90mm Z Profile Modifications

Modification necessary to allow 90mm tall profile Z sections to be handles by Stuga Machines Liniar LCW9022

Sawing Clamps - ZX5

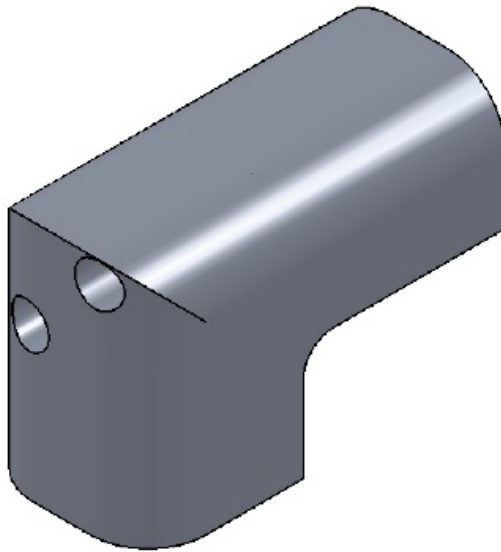
The side clamp block D0015174 are modified to allow a roller at a higher position to coincide with the top edge of the 90mm profile

This is a permanent change to this block, and the additional rollers can be fitted as an optional extra - kit is R0019222 includes the fence or R0019222B if the fence is already modified

A larger Z block D0015178B is also added to this kit to prevent potential pivot points on the taller Z section.

V Notch Clamps - ZX4

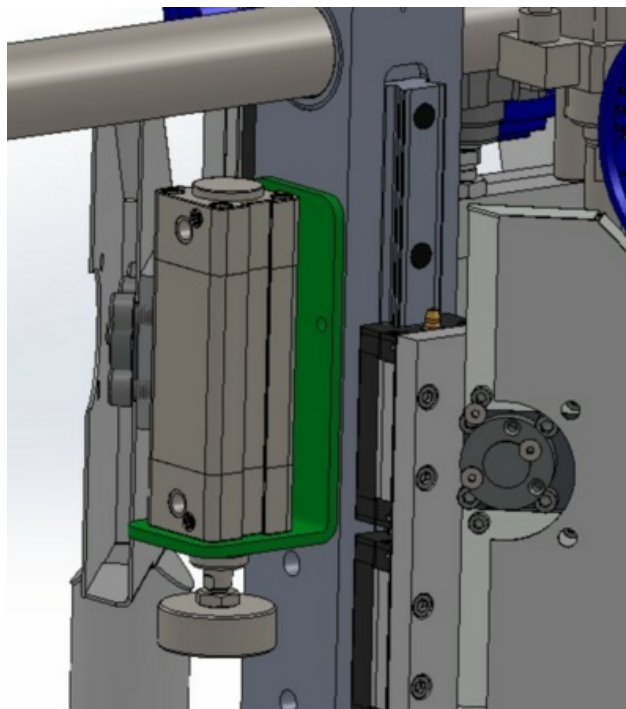
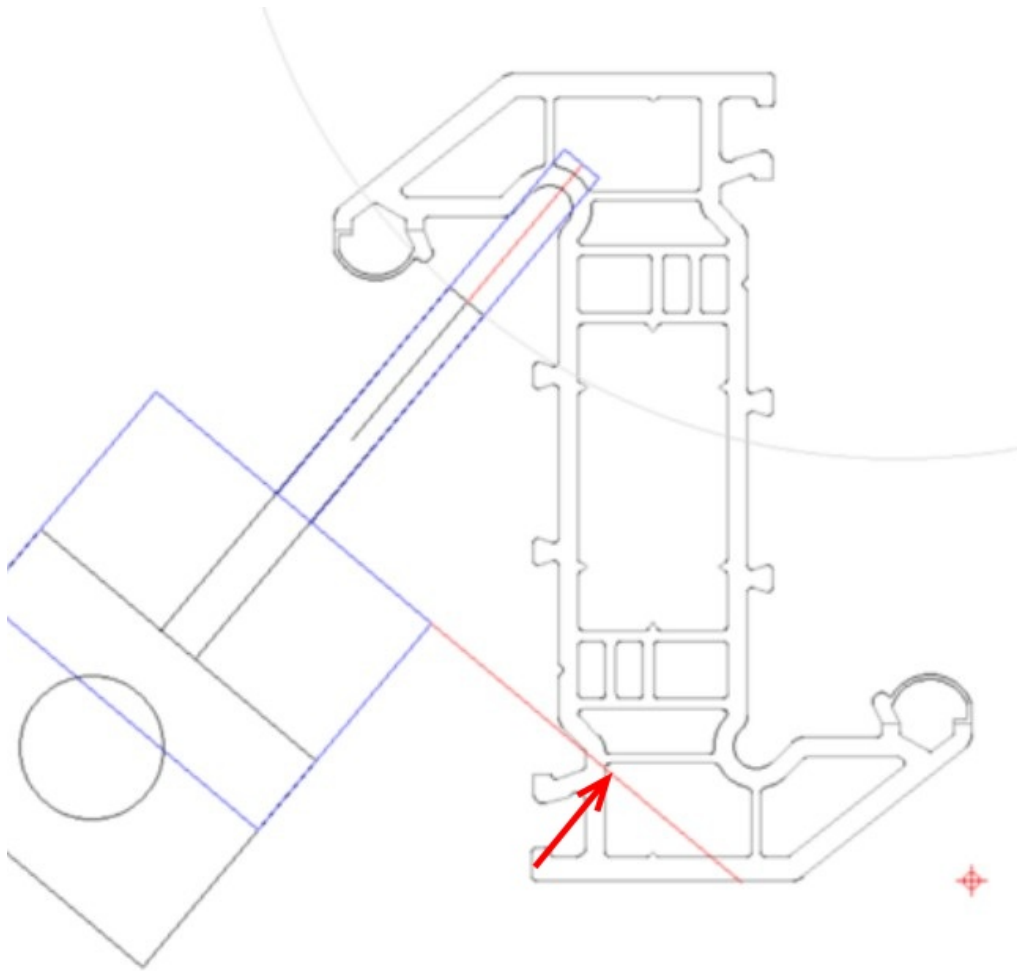
- R0019272 subassembly created for a ZX4 Package
- Includes bracket to raise the V notch clamp to clear 90mm as shown

See ECN0213 for design specification
